Grob G115 Series Aeroplanes

AIRWORTHINESS DIRECTIVE

AD/GROB 115/12
Amdt 1

Elevator Trim Tab

Figure 1
Elevator Trim Tab Hinge
Typical

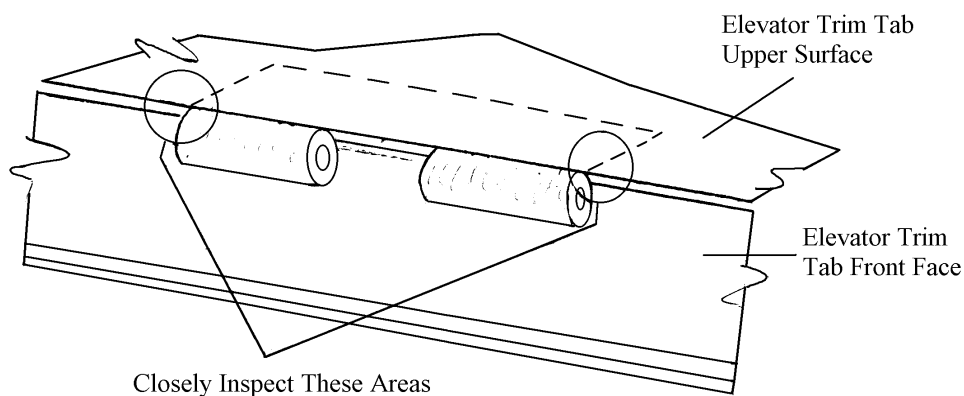
Inspect using a x 10 magnifying glass around all Elevator Trim Tab hinges for cracking or debonding between the hinge tabs and the resin (See Figure 1). Not only the upper surface of the tab is to be examined, but close attention is to be paid to the junction between the sides/lower surface of the hinge flap and the forward edge of the elevator trim tab.

Note 2: The flap segment of the hinge attached to the trim tab runs under the upper surface of the tab.

Note 3: The debonding of the hinges appears as 'cracking' along the line joining the resin and hinge tabs. The growth rate of any cracking will be extremely fast. Further, the crack progression will not be uniform nor similar to fatigue cracking. Therefore, any cracking found is indicative that the entire hinge has debonded.
